CHICAGO PLAN COMMISSION

ELAM PLACE CONDOMINIUMS

3006 – 3012 East 78th. Street / 7th Ward / Ald. Greg Mitchell

SUMMARY OF COMMENTS

CANTILEVERED CONCRETE PLANK BALCONIES

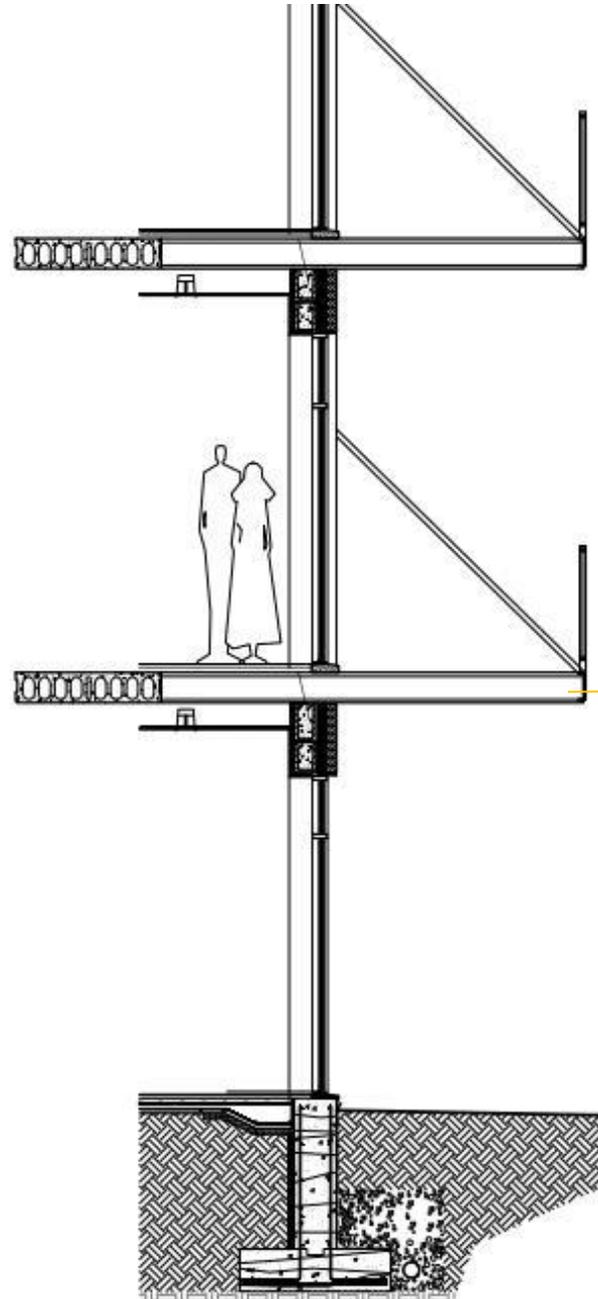
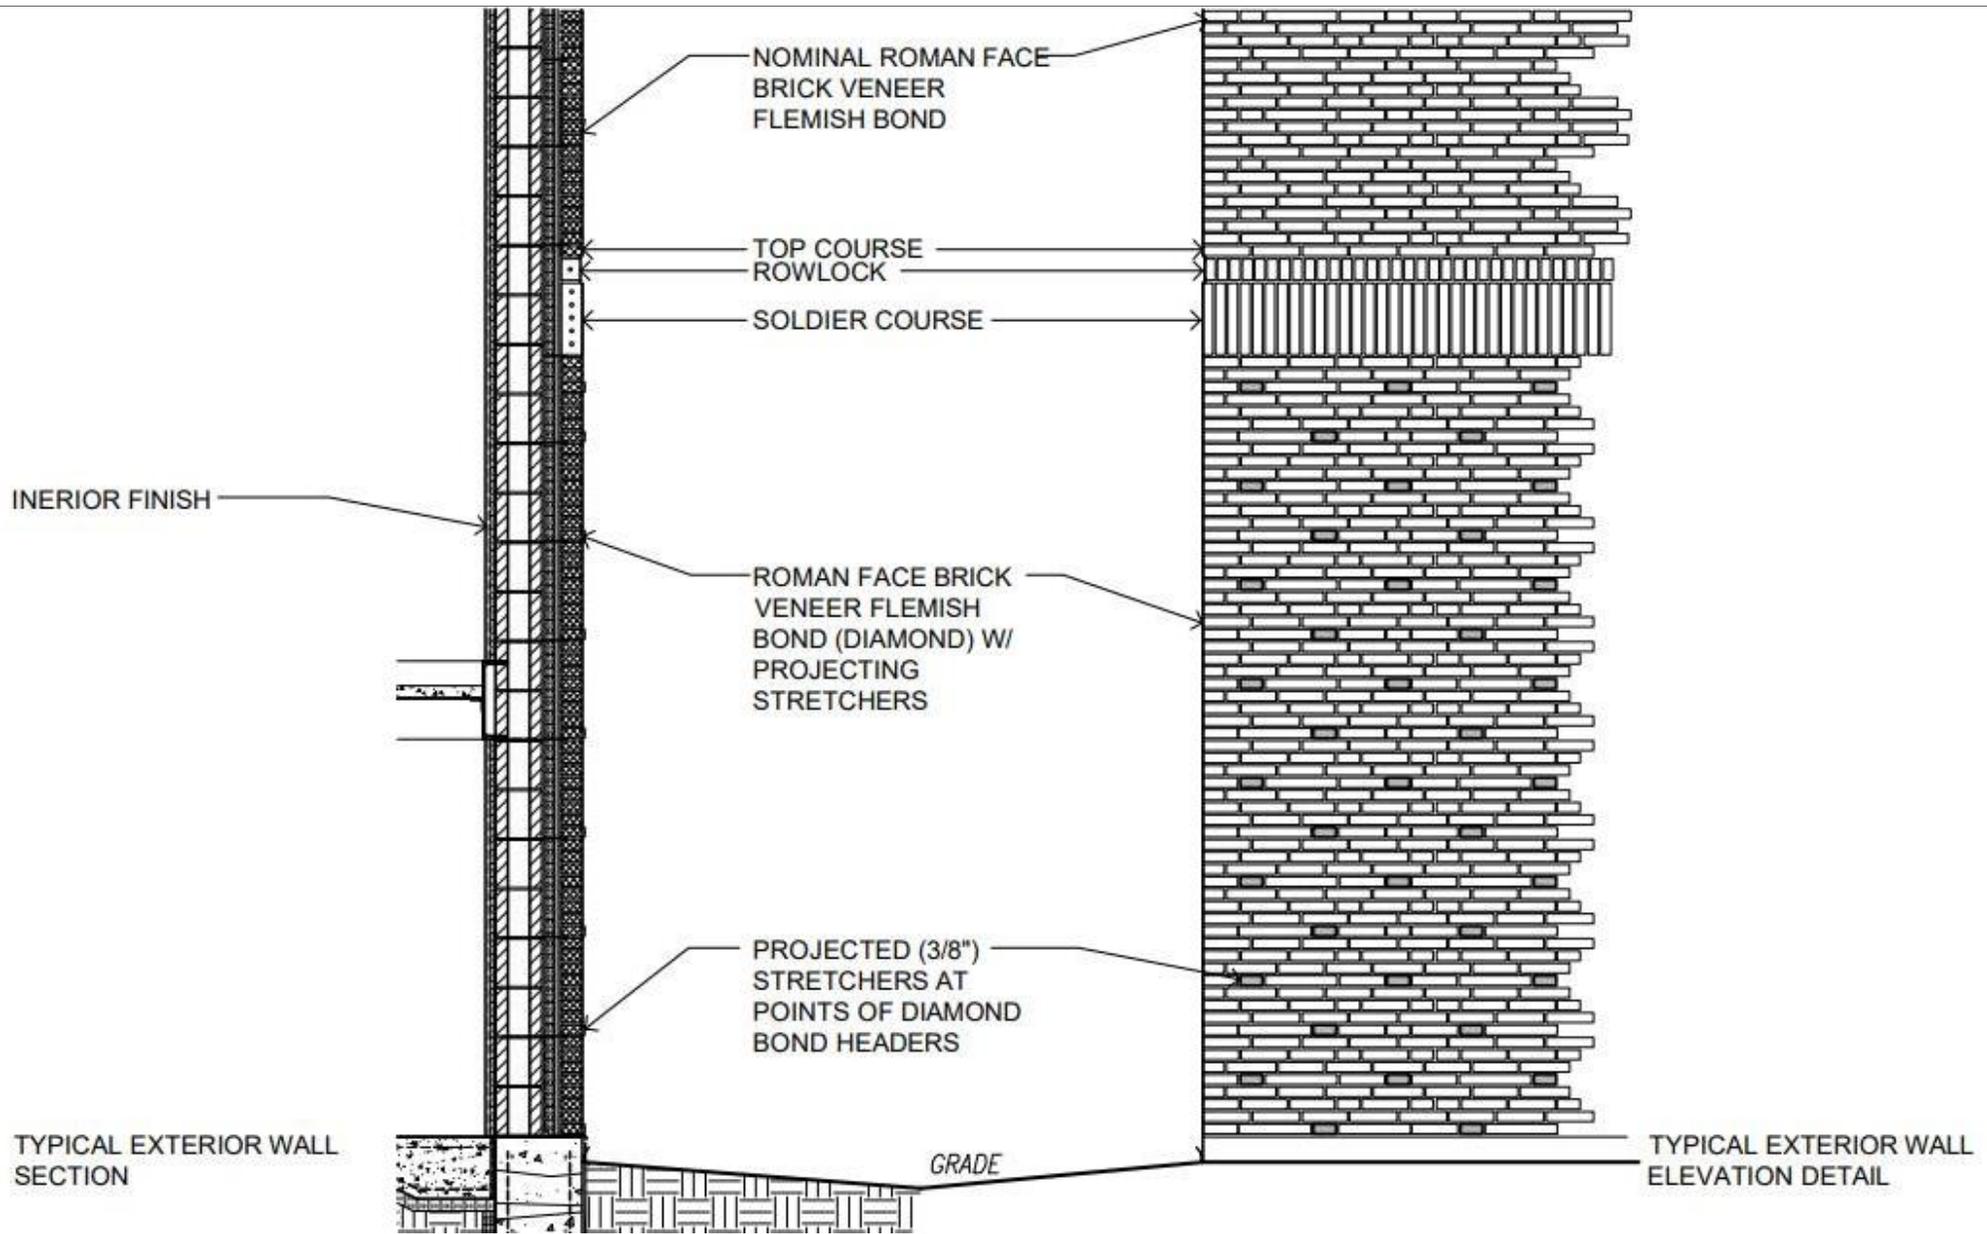
- I. Align windows: We have provided renderings & Elevations reflecting this change. (see pages 22, 30–35)
- II. Suggested to remove tension (triangular members shown on renderings) supports at balcony. Due to the direction of our structural concrete floor planks we need these tension members to augment the structural support of the balconies, since DPD directed us to remove the previous support column supports. At the request of your reviewer, the triangular balcony side screen has been removed and replaced with a simple tension member. (see pages 22 and 38)

DUE TO THE ELIMINATION OF THE SUPPORT COLUMNS & THE SPAN DIRECTION OF THE CONCRETE HOLLOW CORE PLANKS, TENSION SUPPORTS OF THE BALCONIES ARE NECESSARY TO MEET THE REQUIREMENTS OF 100#/SF
